Land North-East of Junction 10 of the M42 Motorway: Appendices to the Proof of Evidence of Jeremy Smith BSc (Hons), DipLA, CMLI

Appeal Reference: APP/R3705/W/24/3336295

Response to Review of Additional Information prepared
by LUC on behalf of North Warwickshire Borough Council

Alternative indicative masterplan used to prepare the Type 3 photomontages

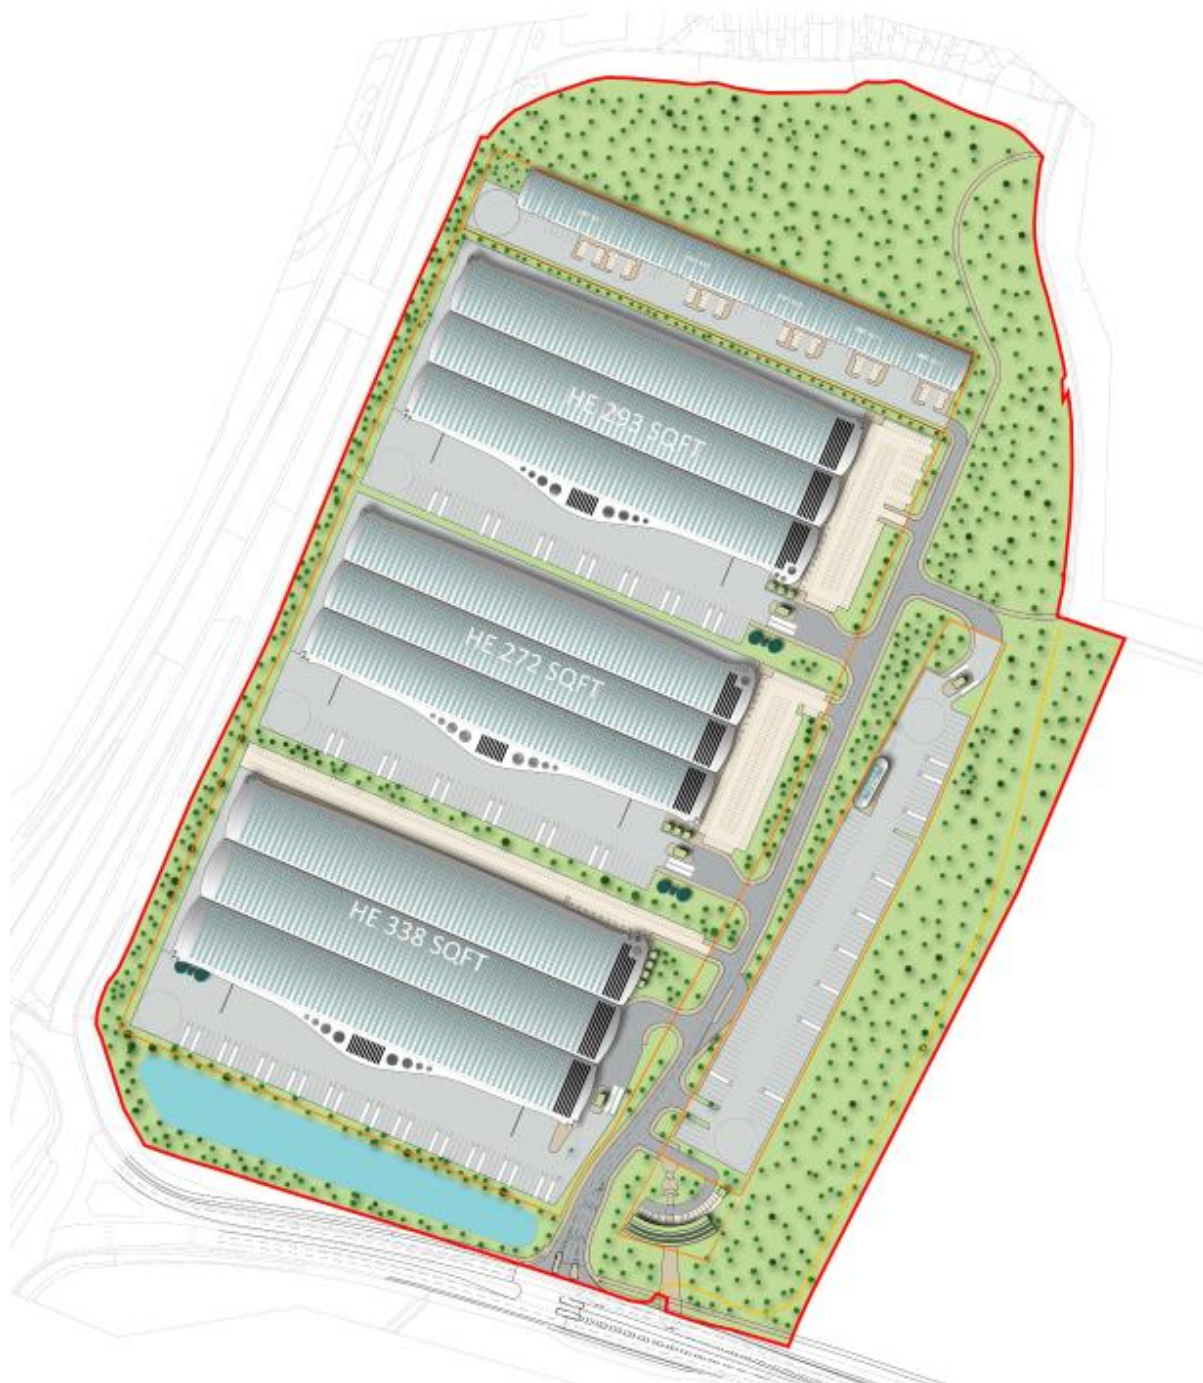
The LUC 4th response notes the inclusion of the alternative indicative masterplan which has been used for the Type 3 photomontages which is considered useful. Both versions of the indicative masterplan are included below.

An alternative indicative masterplan was prepared and used to prepare the Type 3 photomontages. .

Figure 1: Cross section of the architect's 3D model as used in the Type 3 Photomontages. Ridge height from ground level is 24.641m, with parapet height at 21 metres above ground level.

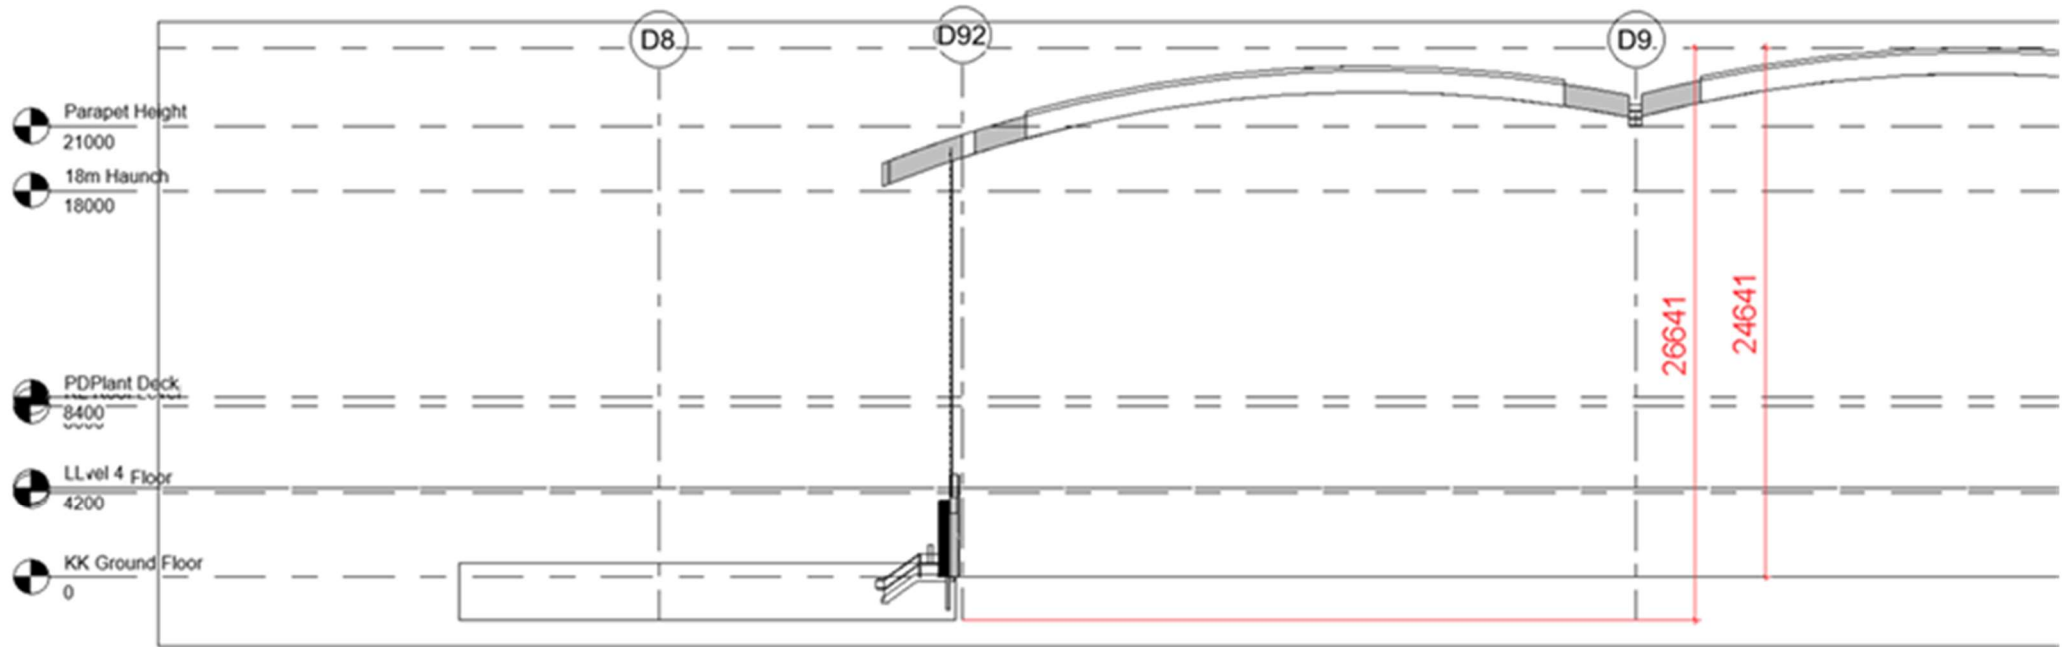
However, the Type 3 montages are based upon an earlier version of the building design that had a building ridge height of 24.641m, or 121.441m AOD, *which is 3.641m higher than proposed ridge height*. **Figure 1**, below, provides a cross section through the architect's model used in the Type 3 montages. As **Figure 1** shows, it is the *parapet height that is actually at 21m* above ground level in the architect's model, not the ridge height.

- One set will have the curved roof buildings as illustrated in the original Type 3 montages, but with the maximum ridge height shown as 117.8m AOD. Year 1 and year 15 versions will be prepared, with bare trees shown at up to 8 metres tall;
- The second set will show a block representation of the parameter plan, with the main building extending up to 117.8m AOD. All buildings in this block montage will be up to a maximum of 117.8m AOD, and all buildings will be shown as having a flat roof. Again, year 1 and year 15 versions will be prepared, with bare trees shown at up to 8 metres tall;
